6 SAFETY ASSESSMENT AND MANAGEMENT PROCESS

In accordance with FAA Safety Management System (SMS) guidelines, the FAA determined that a formal Safety Risk Management Panel (SRMP) should be formed to review ABIA's proposed airside improvements associated with the 2040 Master Plan Future Airport Layout Plan (ALP).

As part of a two-stage safety assessment, 17 potential airfield design hazards were reviewed during a formal Safety Assessment (SA) conducted on June 21, 2018. The session was attended by the SRMP comprising of 11 panelists (14 invited) and five observers/non-panel attendees. See Section 6.4.3.2 for additional meeting details including a list of attendees. The SRMP analysis was performed through review of the following items:

Exhibit 6.3-2: Proposed Airfield Layout (2037)

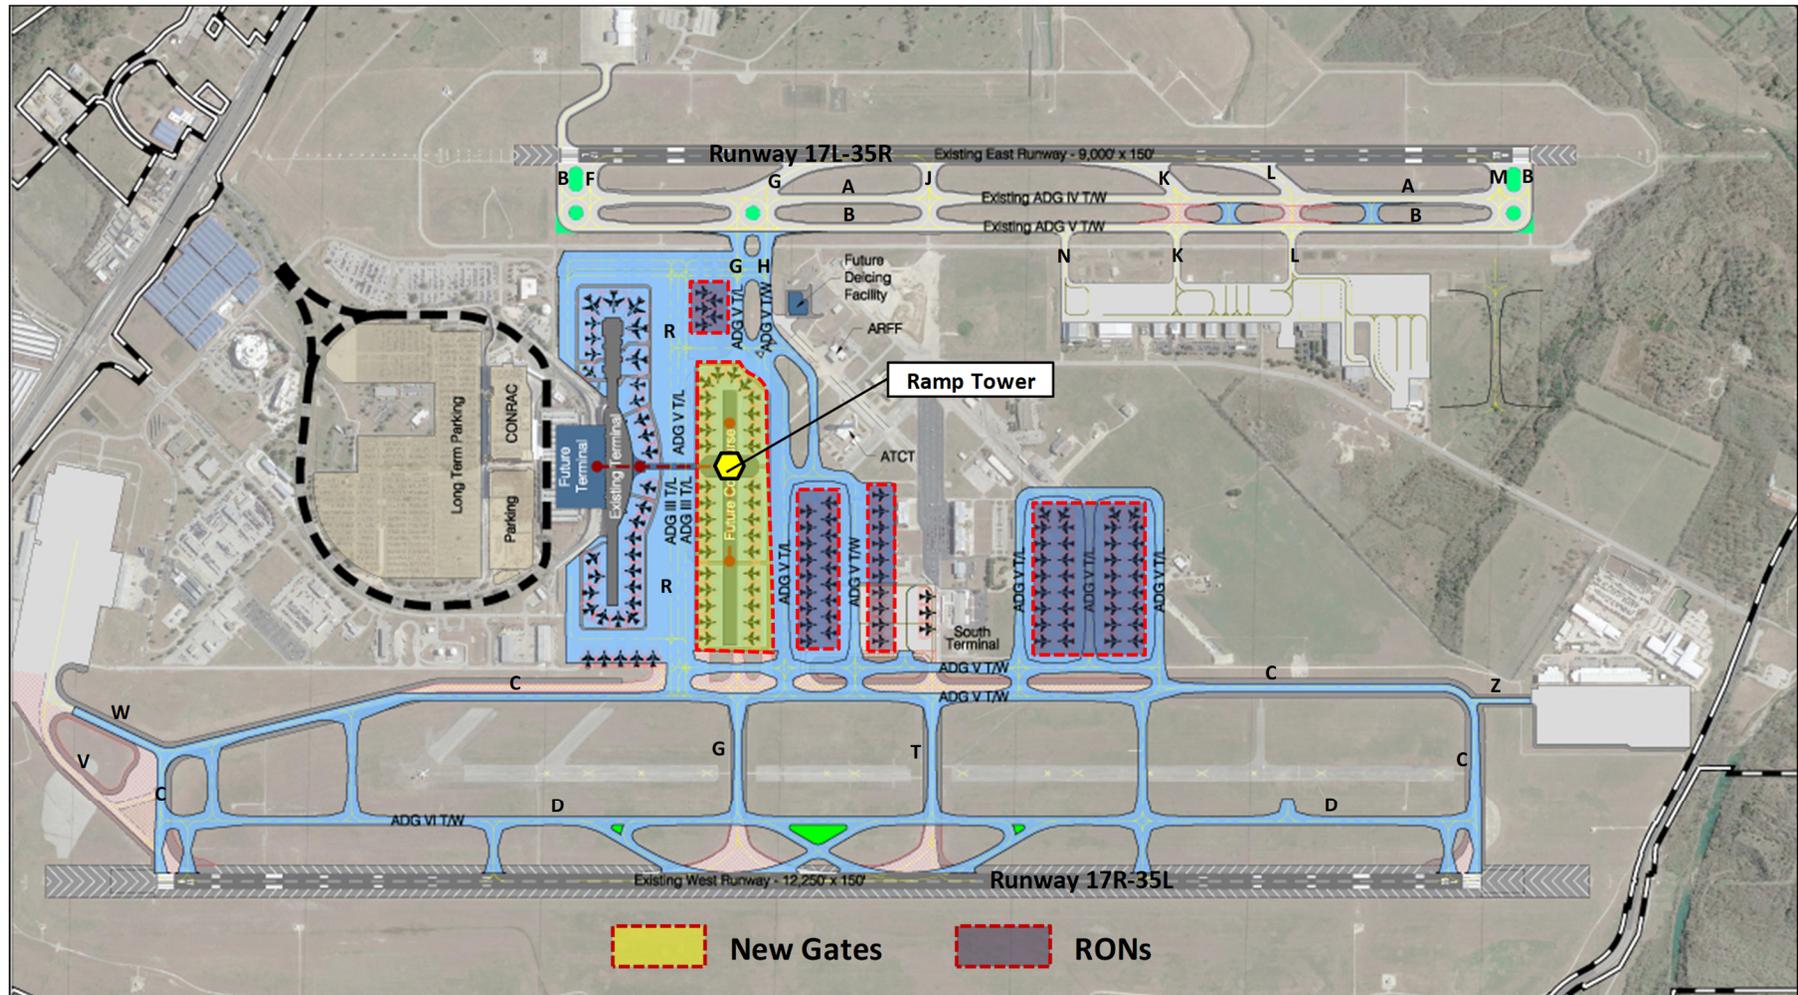
Existing Taxiways K and L have direct access from the General Aviation ramp to Runway 17L-35R which, per FAA and identified Geocode #8 “Taxiways that lead directly from an apron to a runway are not recommended. These configurations may create the false expectation of a parallel taxiway prior to the runway which could lead to confusion and runway incursions.”

Action: To resolve this hazard, the proposed solution is to modify the Taxiways K and L access into the General Aviation/Fixed Base Operator (GA/FBO) ramp area (see Proposed New Airfield Layout in **Exhibit 6.4-2**). With the applied solution, this potential hazard was eliminated.

Exhibit 6.3-3: New Runway 17C-35C Layout

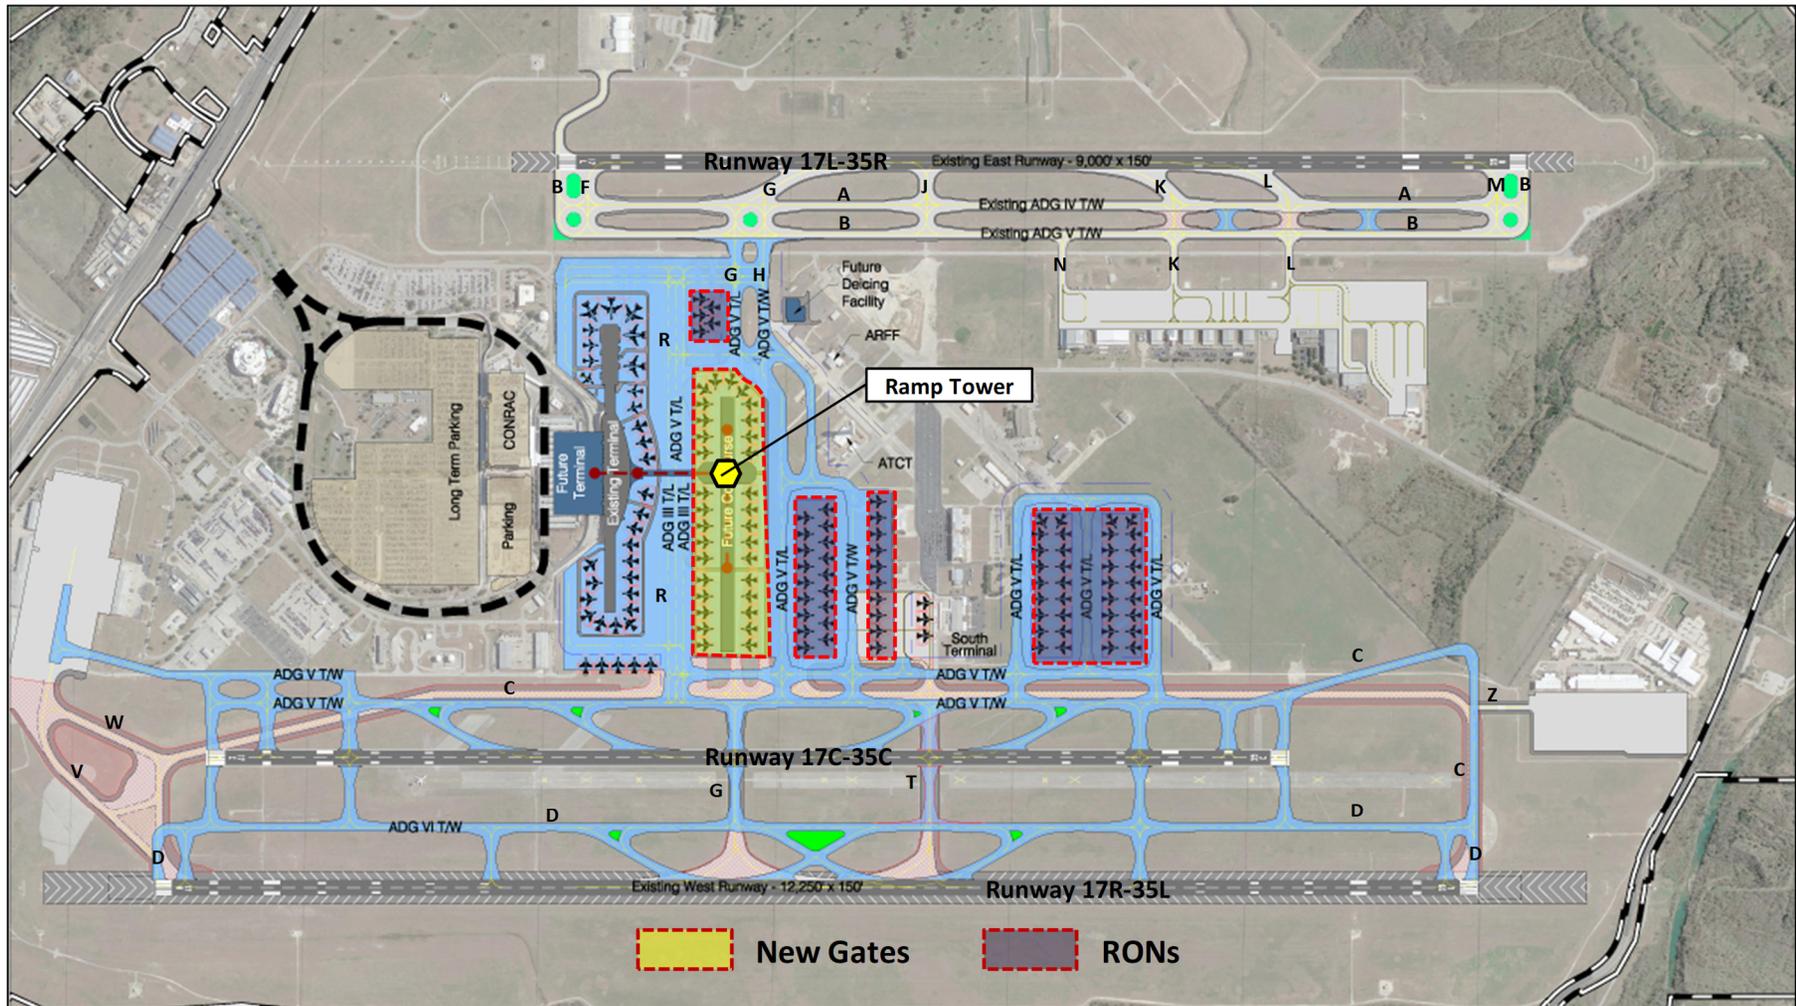
The taxiway intersection to the new Runway 17C-35C design will have connector taxiways crossing the runway from existing Taxiway D. This could result in pilot loss of situational awareness and the pilot could inadvertently cross-Runway 17C-35C prior to contacting ATC. Note this hazard becomes an issue only when the new proposed Runway 17C-35C is built (post 20 yrs.).

Action: Taxiway G will be eliminated with the implementation of the new proposed Runway 17C-35C. The first Rapid Exit Taxiway in each direction will be eliminated on Runway 17C-35C. Taxiway T will remain in place and a new 90-degree exit will be located approximately 3,000 feet from the 17C threshold. These proposed solutions as shown in **Exhibit 6.4-3** were determined by the SRMP to be sufficient to eliminate this potential hazard.
